PRODUCT CHANGE NOTIFICATION

E-Switch Series/ Part No affected:
P040038, P040040, P020092, P040039

Part /Series Description:
EG1218 Series

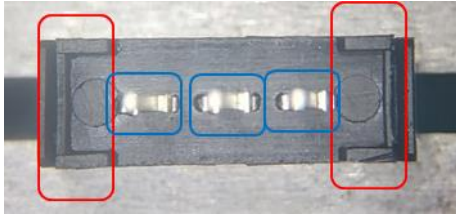
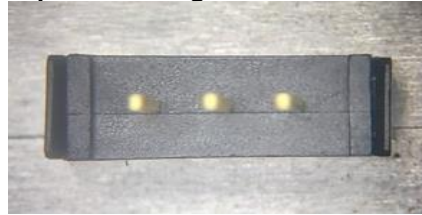
1. **Current manufacturing has the terminals pressed into switch base and then epoxy around terminals. The process change is to insert mold the terminals into the switch base. This will eliminate the need for epoxy on the bottom of the switch**

Proposed Transition/change over: This will be a "running" change since the new inserted molded base does affect any type of "Form, Fit, or Function" of the switch and there isn't any change to any of the switch specifications.
